**Rockland County Solid Waste Management Authority**

#### RFP 2021-13

#### **MECHANICAL**

SUBJECT: ADDENDUM NUMBER 4

**DESIGNED** BJZ APPROVED CAD FILE: N:\2021\21033\MEP\21033 M-103.DWG ph: 631-756-1060 fax: 631-756-1064 APPROVED SHEET SIZE: D-24x36

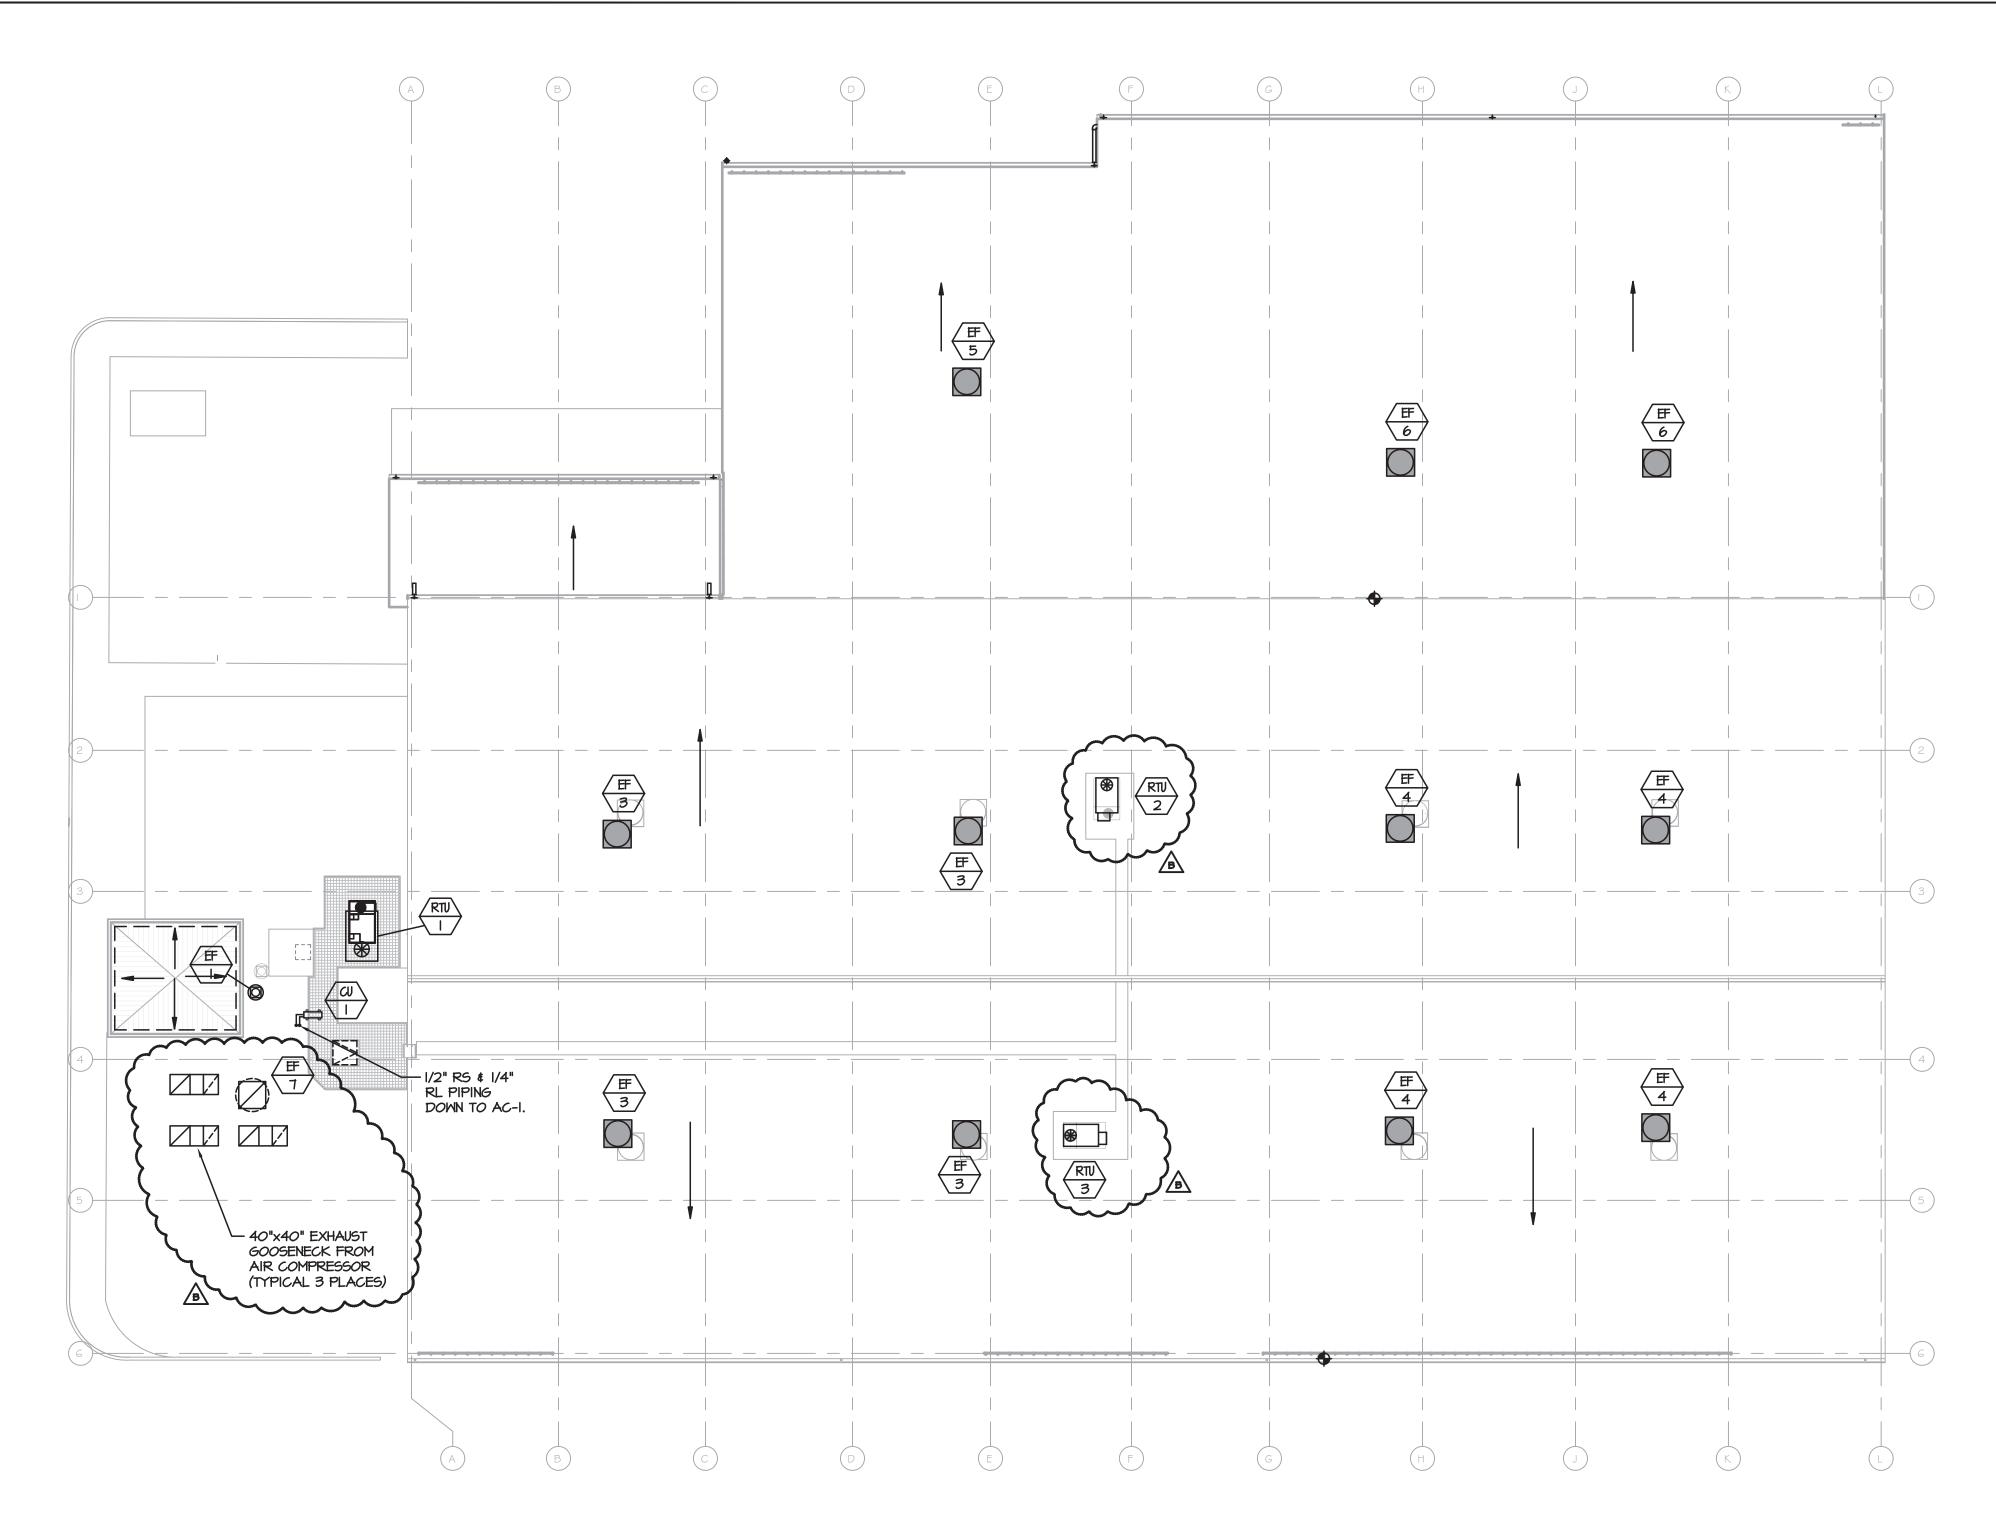
- B. Revised Demolition Notes.
- 5. Drawing M-103
  - A. Revised Demolition Notes.
- 6. Drawing M-201
  - A. Added intake louver, exhaust louver, exhaust fan and electric unit heater to Electrical 113.

BY DATE BJZ M-203 **DESIGNED** BJZ **RRT Engineering , LLC** CAD FILE: N:\2021\21033\MEP\21033 M-203.DWG APPROVED ph: 631-756-1060 fax: 631-756-1064 APPROVED REV SHEET SIZE: D-24x36

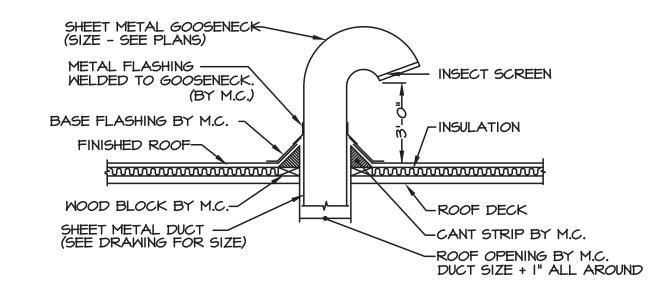
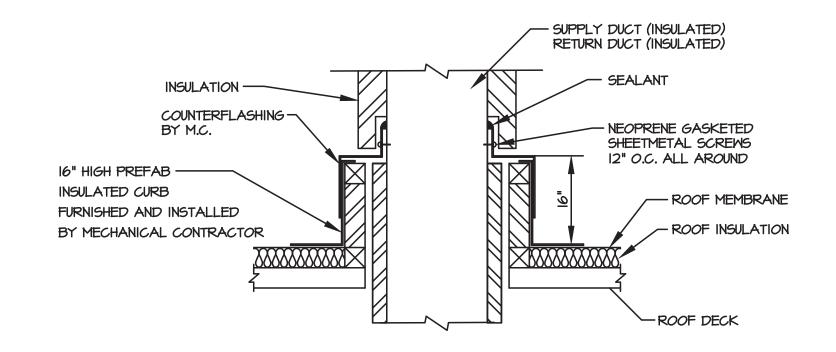
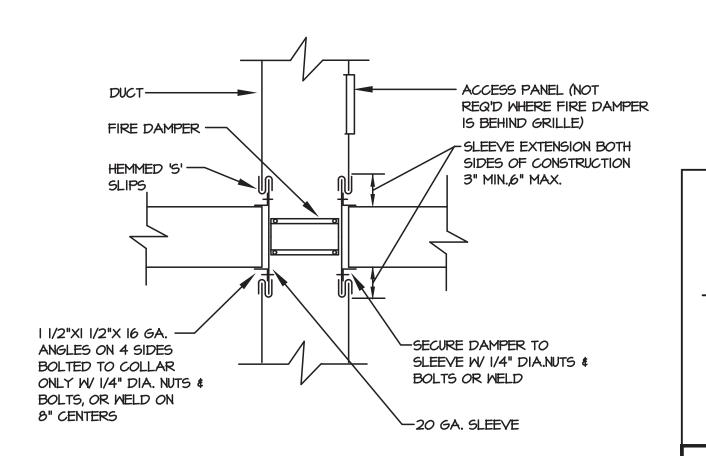
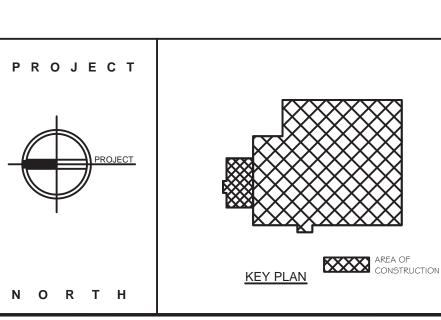
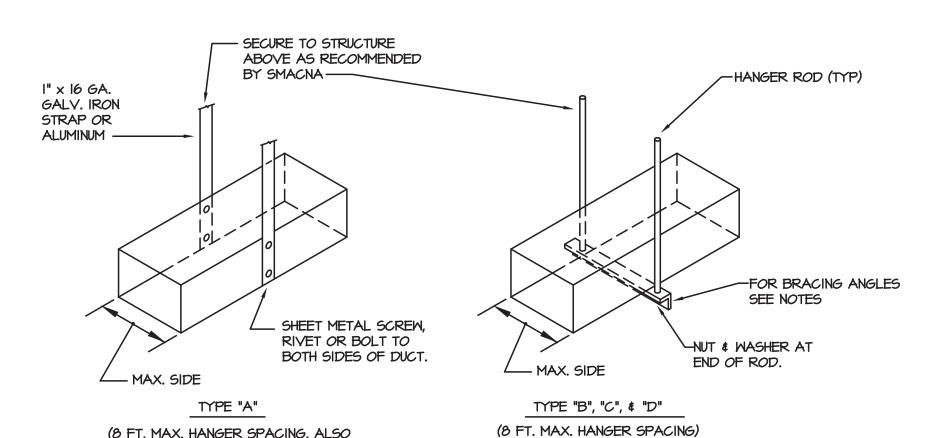
- A. Revised louvers, added flues for unit heaters and revised Mechanical Installation Notes.
- 8. Drawing M-203
  - A. Added Mechanical Installation Notes.

- B. Added exhaust fan and goosenecks from compressors.
- 9. Drawing M-401
  - A. Added Tag (H) to Diffuser, Register & Grille Schedule.
- 10. Drawing M-402
